Project	IEEE 802.16 Broadband Wireless Access Working Group < http://ieee802.org/16 >
Title	Proposed text and ASN.1 code to support CID update TLV
Date Submitted	2007-05-02
Source(s)	Joey Chou Intel Corporation [mailto:joey.chou@intel.com]
Re:	
Abstract	This contribution proposes the text and ASN.1 code in wmanIf2Mib to support CID update TLV.
Purpose	Adoption
Notice	This document has been prepared to assist IEEE 802.16. It is offered as a basis for discussion and is not binding on the contributing individual(s) or organization(s). The material in this document is subject to change in form and content after further study. The contributor(s) reserve(s) the right to add, amend or withdraw material contained herein.
Release	The contributor grants a free, irrevocable license to the IEEE to incorporate material contained in this contribution, and any modifications thereof, in the creation of an IEEE Standards publication; to copyright in the IEEE's name any IEEE Standards publication even though it may include portions of this contribution; and at the IEEE's sole discretion to permit others to reproduce in whole or in part the resulting IEEE Standards publication. The contributor also a

Figure 16— wmanIf2mBsCm structure

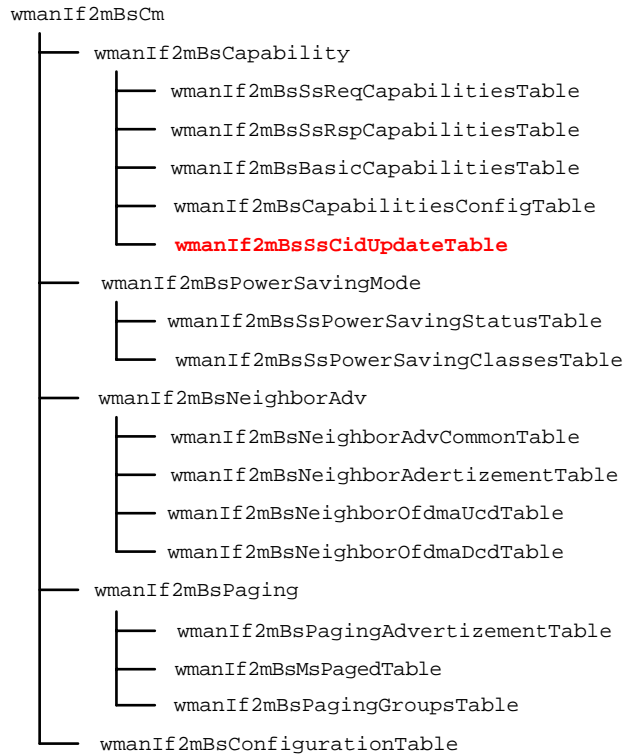
[Change Figure 16 as the following:]
